**Santos**

18 April 2019

I refer to the assessment application for petroleum activities for the Cherokee and Piute Project (RPI19-001 – Cherokee and Piute) and your request for further information dated 9 April 2019. A response to the matters raised in the requirement notice are addressed in this document and attachments as outlined in Table 1 (see over page).

**Table 1: Response to Requirement Notice Dated 9 April 2019**

**ATTACHMENT 3 – ACCESS TRACK ROUTE OPTIONS**

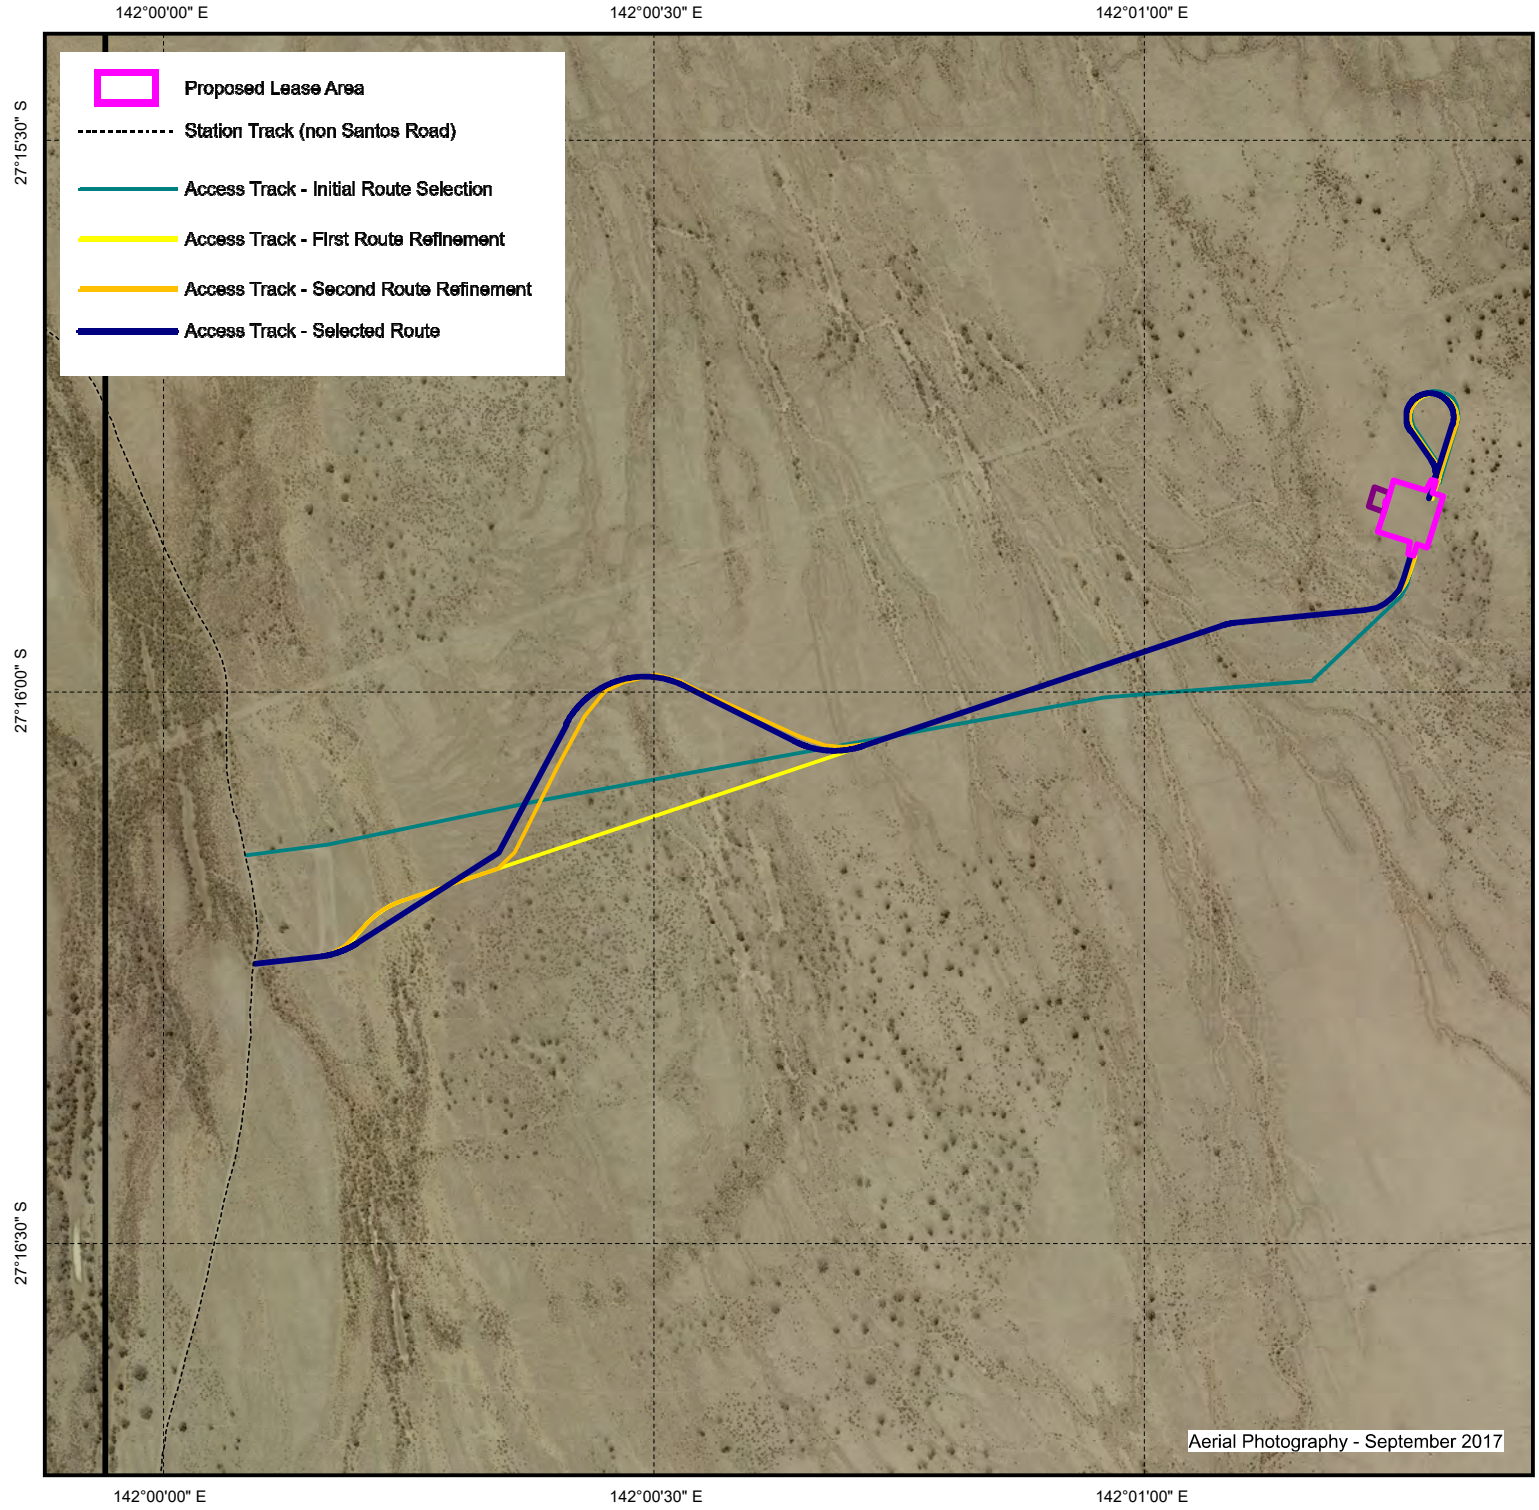
<p><b>Item 2</b></p> <p>Section 2.3 of the Assessment Report (lodged in support of the application) addressed access tracks, noting one 'of these access tracks follows a pre-existing seismic line route'. Please identify the access track referred to and explain how the other access track route was arrived at. (Note: applicants typically provide a plan to identify the route options that were explored).</p>	<p>A section of the Cherokee 1 access track follows 3D seismic line 00-CS5336. A section of the Cherokee 1 pipeline also follows a pre-existing seismic line, 00-CR1576. These seismic lines were part of the 2000 Central Fields 3D Survey Program. Attachment 2 shows the sections of the Cherokee 1 access track and pipeline that follow existing seismic line routes.</p> <p>The location of all infrastructure for the Cherokee 1 and Piute 1 project was planned on desktop and continually refined to ensure minimal overall potential environment impact. The drilling locations (Cherokee 1 and Piute 1) were limited based on downhole requirements and needed to remain within a restricted zone in order to maintain economic feasibility. Refinements of the drilling locations were made to move the wells back further from waterways and to orientate the drilling lease to minimise the amount of clearing required / avoid removing mature trees as much as possible.</p> <p>The access track routes (Cherokee 1 access track and Piute 1 access track) underwent a similar planning and refinement process, in conjunction with the drilling locations. Refinements to the access track routes focused on minimising potential environmental impacts and disturbance to visible vegetation and drainage lines.</p> <p>Attachment 3 shows the proposed access track route alternatives that have been considered and the refinement of these routes. Below is a summary of the planning and refinement that took place.</p> <p><b>Cherokee 1 access track</b> – the initial route [Aqua] was originally selected as it provided the most direct access from the existing Station Track to the drilling location. The first route refinement [Yellow] co-located the Cherokee 1 access track route with the Cherokee 1 pipeline route as much as practicable, minimising the amount of disturbance. The second route refinement [Orange]</p>

Request	Santos Response
	<p>also co-located the linear infrastructure and will avoid more dense vegetation in comparison to the previous proposed routes as it follows a section of pre-existing seismic line. The final alignment selected [Blue] is similar to the second route refinement, though it has been optimised slightly to avoid more dense vegetation resulting in less environmental disturbance. The final alignment may be modified further during the pre-clearing should it be determined that areas (once ground-truthed) require additional management. Note: existing disturbance north and running parallel to the Cherokee 1 linear infrastructure is the Carpentaria Gas Pipeline (PPL 41) and not an existing access track that could have been utilised (as it appears in Attachment 3).</p> <p><b>Piute 1 access track</b> – the initial route [Aqua] was originally selected as it provided the most direct access from the existing Station Track to the drilling location (note existing Station Track is located on an adjacent tenure to PL 1047). The first route refinement [Yellow] co-located the Piute access track route with the Piute 1 pipeline route where possible, and allowed for loop road to be slightly set back from the nearby Cooper Creek. The final alignment selected [Blue] is similar to the first route refinement, though it allows for both the drilling pad and loop road to be adequately set back from the nearby Cooper Creek resulting in less potential for environmental disturbance. All route options considered for the Piute 1 access track avoid areas of dense vegetation as far as practicable. Existing disturbance was also considered, however there are no existing roads, and it wasn't feasible to utilise pre-existing seismic lines for this site (would have required more surface disturbance than the alignment selected).</p>
